INDESIT company

Model type:
BO3034V

Commercial code:
F027408

0521123: SEALS FOR DOORS FOAMED AS ONE PIECE

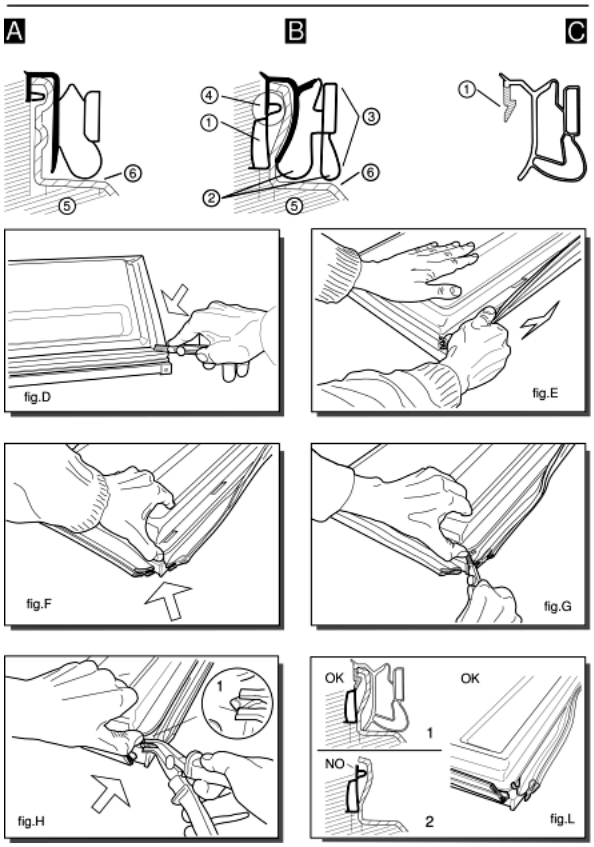
Various types of gaskets with different profile, as shown in figures (A) and (B), are used to fix the door (fig. A-5; B-5) and the inner door (fig. A-6; B-6) on the block foamed doors of combined freezers and refrigerators.
---Ilpea profile 245; 179; 412 (fig.A)
---Ilpea profile 287 (fig.B)
When replacing gaskets with profiles 245; 179; 412 these are fixed with screws (2 per corner) to the door.
Gaskets with profile 287 can not be used as spare parts but are designed to house the Ilpea type 900 gaskets (see figure C).
When replacing the gasket (287), once it is removed you will find a pocket (fig. B-1) between the door and inner door.
The rigid tooth (fig.C-1) of the gasket (900) is inserted inside between the pocket and the inner door, doing away with the need for screws.
Gasket with profile 287 is easy to identify since it has an exterior double edge (fig.B-2) which acts as a cushion when the door is closed.

To replace this gasket, follow these steps:
---Dismount the door and cut the four corners of the gasket along the joint (fig.D);
---lift the gasket and pull it carefully along its full length without tearing it (fig.E).
The purpose here is to detach the inner door slightly from the foam along the exterior edge for a depth equal to that of the gasket (fig.B-3);
---lift the corner of the inner door slightly, prising it up with your thumb (fig.F). Do not use a tool which might break the inner door;
---continue cutting the gasket inside the inner door for about 6 mm (fig.G);
---push in the tip of the pliers (type USAG N131) and pull outwards until you see the top edge of the pocket (fig. B-4) which is empty (fig.H-1);
---if you carry out this operation correctly (fig.L) you will be able to pull off the top edge of the pocket for the full length of the door.
If the gasket tears before the top edge (fig. L-2) you should repeat this operation from the other corner of the door.

---once the gasket (287), has been removed the space above the pocket (fig. L-1) can house the rigid tooth (fig. C-1) of the gasket 900.
When you fit this gasket ensure that it lies flush against the edge for the full length of the door.
If the rigid tooth is difficult to fit, eliminate any residues of foam between the door and the inner door in the gasket area.
fig.5131549A

N130084FIG1

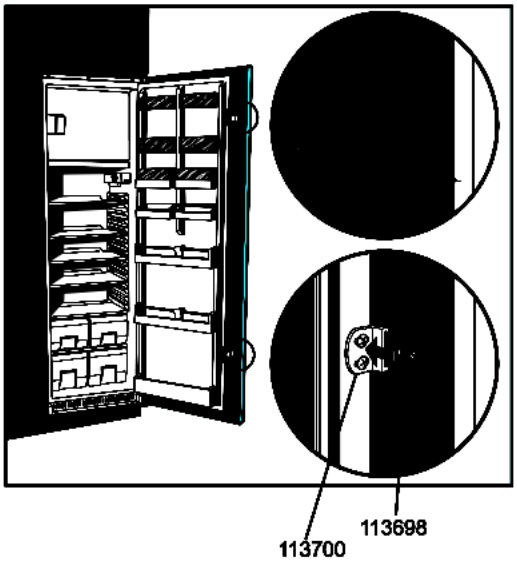
n1030084: New sliding blocks for fixing the furniture door to the refrigerator door

Since October 2004, the Carinaro factory has been using new sliding blocks for fixing the furniture door to the refrigerator door.
The new items are fixed to the side of the refrigerator door, whereas the previous ones were fixed to the front.
The doors are no longer provided with sixteen 2.6 mm holes on the front for fixing the old slides.
The new sliding blocks can also be fitted on premodification models. Proceed as shown in the attached figure (N1030084fig.1).
When replacing the sliding blocks on premodification models it will necessary to replace both guides.
This modification has involved changing the installation KITS

NB - Door spare part codes have not been changed.

New parts

113698 - LARGE NYLON HOLDER SLIDE
113700 - NYLON HOLDER SLIDING GUIDE

Installation kit (models with plastic slides)

C00113967 - REFRIGERATOR INSTALLATION KIT INC. 2/P 290L (10/2004)
C00113968 - REFRIGERATOR INSTALLATION KIT INC. 2/P 290L (10/2004)
C00113970 - REFRIGERATOR INSTALLATION KIT INC. 2/P 240L (10/2004)
C00113971 - FREEZER INSTALLATION KIT INC 1/P 200L (10/2004)
C00113973 - FREEZER INSTALLATION KIT INC 1/P 140L (10/2004)
C00113974 - REFRIGERATOR INSTALLATION KIT INC. 1/P 130L 10/2004)
C00113975 - FREEZER INSTALLATION KIT INC. 2/P 300/330L (10/2004)
C00113977 - REFRIGERATOR INSTALLATION KIT INC.1/P 230L (10/2004)
C00113979 - REFRIGERATOR INSTALLATION KIT INC.1/P 160L (10/2004)
C00113985 - FREEZER INSTALLATION KIT INC 2/P 300L (10/2004)
C00113986 - FREEZER INSTALLATION KIT INC 2/P 300L (10/2004)
C00113987 - FREEZER INSTALLATION KIT INC 2/P 240L (10/2004)
C00113988 - REFRIGERATOR INSTALLATION KIT INC.1/P 300L (10/2004)
C00113989 - REFRIGERATOR INSTALLATION KIT INC.1/P 300L (10/2004)
